Product Change Notification

Product Change Notification: P-21-020302

Terminal

Packing spec changes. Start the shipment from Mar-'21, Running change. Detail refer to below link. No mixed shipment existing packing style and new packing style. See attachment file. / This PCN is the updated of P-21-020291(PCN Date 12-JAN-21), part number 1827855-3 added.

I. Paper reel

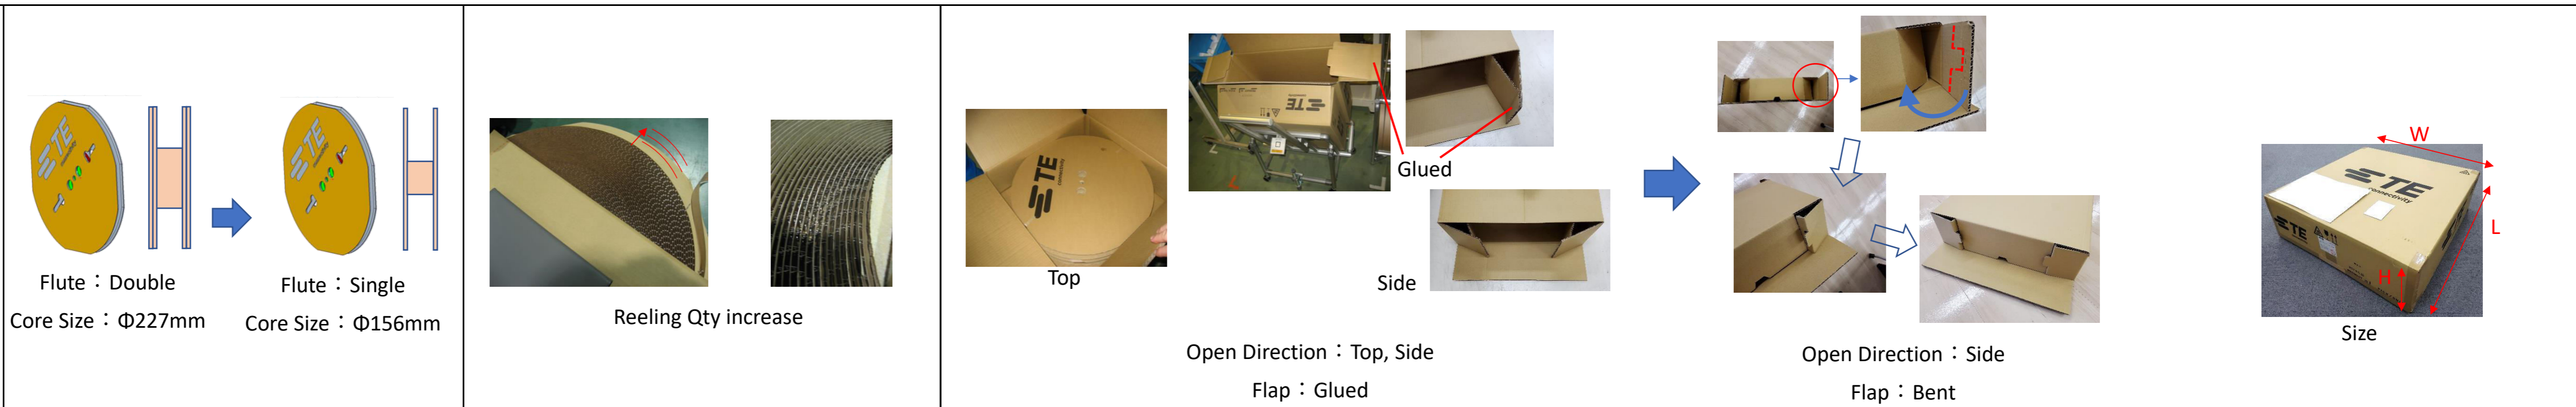
Standardization from double flute $\Phi 227\text{mm}$ core to single flute $\Phi 156\text{mm}$ core.
